ATR on Quality Control Check Report. (Bungalows)

**Quality Control Check Report. Stage: After Column Casting (Villas)**

Block No.	116	Column No.	02	Sl. No.	30300
Company	Nilgiri estates	Project	Nilgiri estate	Phase	T
Prepared by	P. Sai Kumar	Sign	[Signature]	Date	21/5/18
Project Manager	Maheshwathan	Sign	[Signature]	Date	21/5/18
Previous stage report no.		Report filed and signed by PM?		<input checked="" type="checkbox"/> Yes <input type="checkbox"/> No	
Checked By MD on	30028	MD Sign		<input type="checkbox"/> Yes <input type="checkbox"/> No	
Recommendation:					
<input type="checkbox"/> Stop further work. Submit ATR on QC report to QC team. Proceed only after recheck by QC. <input type="checkbox"/> Stop further work. Proceed with work after submitting ATR on QC report to QC team. <input checked="" type="checkbox"/> Proceed with further work only after making corrections pointed out in the QC report. ATR not required. <input type="checkbox"/> Proceed with further work. ATR not required.

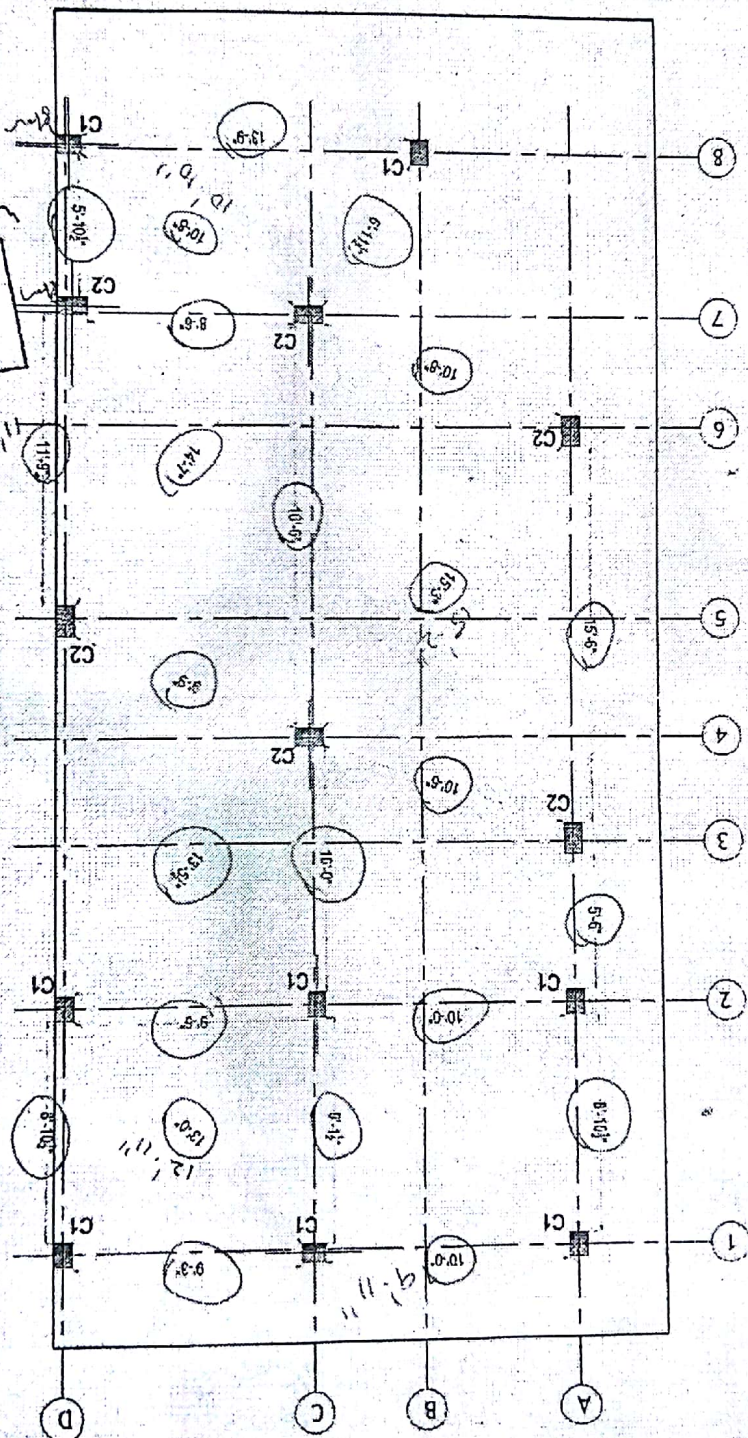
3. Circle each correct dimension with green colour. Circle each incorrect dimension with red colour and mention actual dimension next to it.

*Ms-116*  
*Col-02*  
*11.8"*
